# Illustrated Parts List - IPL Update

**372 XP**

## 2. Sleeve

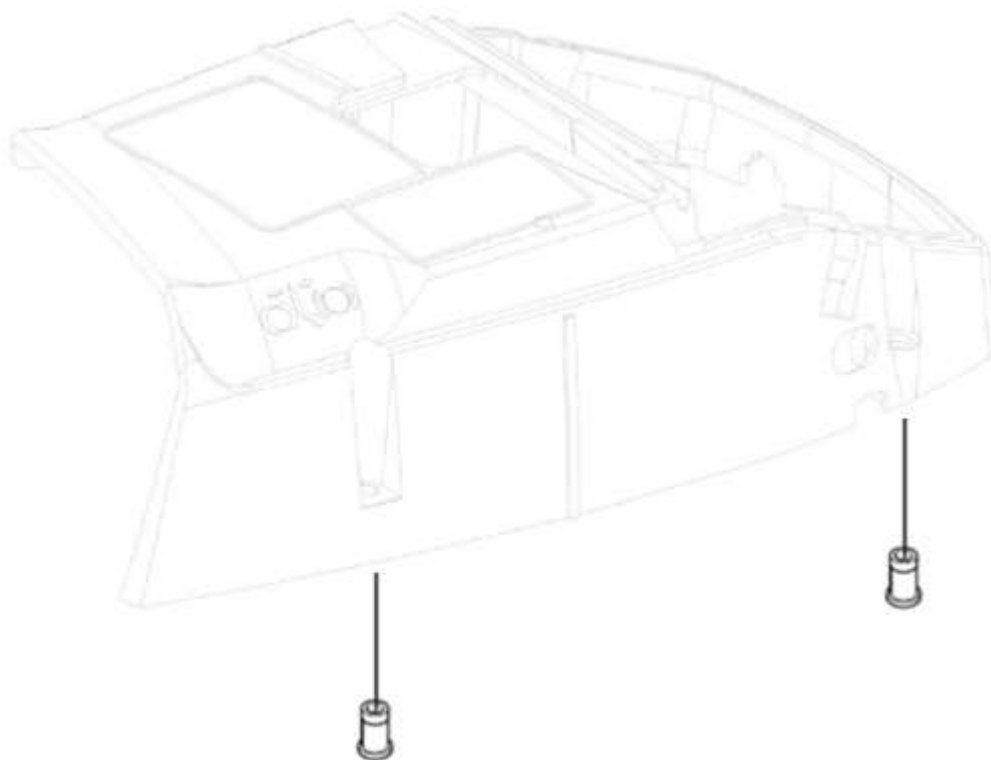
1. New screw with torx grip to cylinder cover provides better condition for tightening. Torx wrench added in tool kit.
2. New sleeve to cylinder cover. Available as separate spare part
3. New. Clutch with higher specification.
4. New reinforced recoil spring
5. Torx wrench added in tool kit. Tool kit included in box. Grease and Grease gun removed from tool kit.
6. Torx wrench T27/T20 available as spare part

537 05 59-03
